TITLE UPPER SECTOR TRANSDUCER ADJUSTMENT				PIB NO. DK-3013	
PRODUCT LINE	TAPE DISK FORMATTER	EQUIPMENT CHANGED Sector Pick-Up	MODEL SERIES AFFECTED D3000	EFFECTIVE DATE June 7, 1974	
CLASS OF BULLETIN:		ORDER PART KIT NO.	EFFECTIVITY		
<input type="checkbox"/> IMPROVEMENT <input type="checkbox"/> RETROFIT ON FAILURE <input type="checkbox"/> RETROFIT RECOMMENDED <input checked="" type="checkbox"/> INFORMATION ONLY <input type="checkbox"/>		N/A	ALL MECHANICALLY SECTORED TOP LOAD UNITS  NOTE: THIS PIB DK-3013 REPLACES SERVICE INFORMATION NOTE DK-3009 IN ITS ENTIRETY. REMOVE & DESTROY SIN DK-3009.		
<p><b>PURPOSE</b> Latest reports indicate that some disk pack vendors are utilizing 20 mil sector notches in their pack sector rings. Should the D3000 be adjusted for a standard 80 mil notch, low amplitude at LTPE2 (Figure 1) could result.</p> <p>Symptoms of low amplitude:</p> <ul style="list-style-type: none"> <li>• Missing sector pulses</li> <li>• Wrong Sector Counts</li> <li>• Unexplainable controller time-outs.</li> </ul> <p>To date there is no known standard for notch widths on mechanically sectored packs, however, compensation for the 20 mil notches may be made using the following pr

FIGURE 1

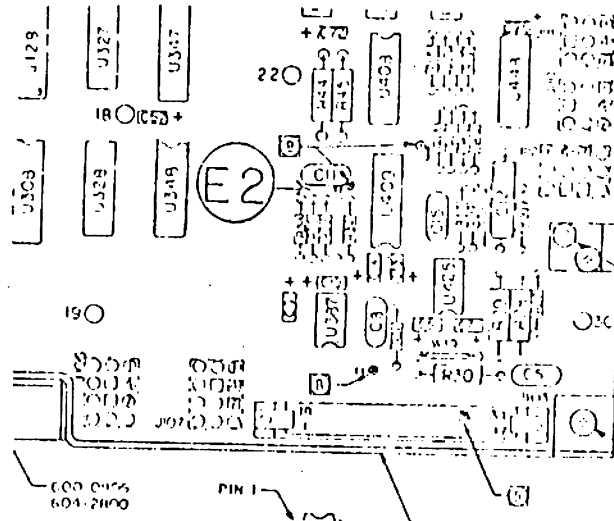
- 1.3 Upper sector transducer may be adjusted by utilizing D3000 manual Rev. C., Pages 6-128, 6-130, Section 6-18 (Magnetic Transducer Gap).

A DISK PACK MAY BE DISASSEMBLED AND THE SECTOR RING USED FOR ADJUSTMENT IF NO ADAPTER BOWL SET-UP TOOL (103619-01) IS AVAILABLE.
